SERVICE BULLETIN

TR-9000

#825

SUBJECT: TR-9000 TX PULSE NOISE IN SSB MODE

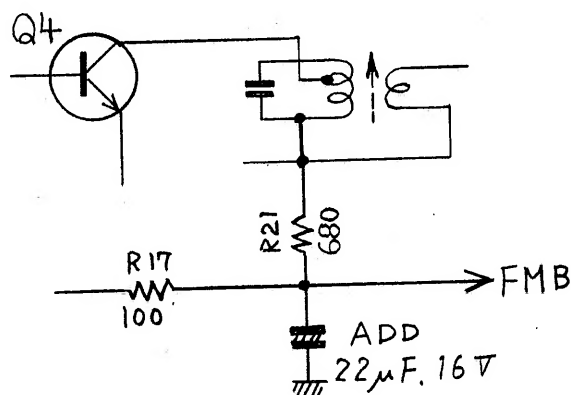
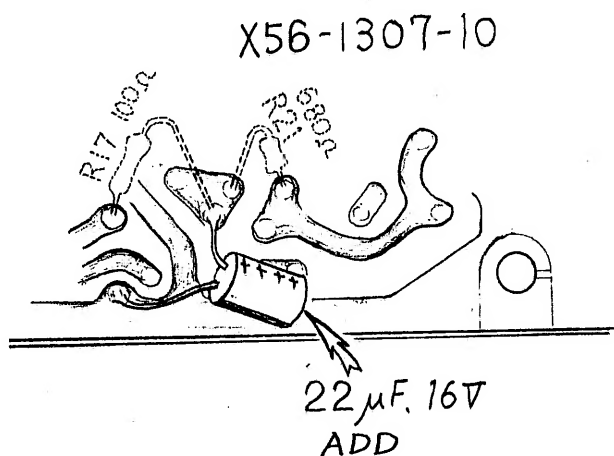
Pulse noise heard during SSB transmission may be reduced or eliminated by adding one capacitor to the TX unit.

On the TX unit X56-1307-10 add a 22 μ F 16V radial lead cap to the FMB line, as illustrated, on the foil side of the PCB. No adjustments are necessary.
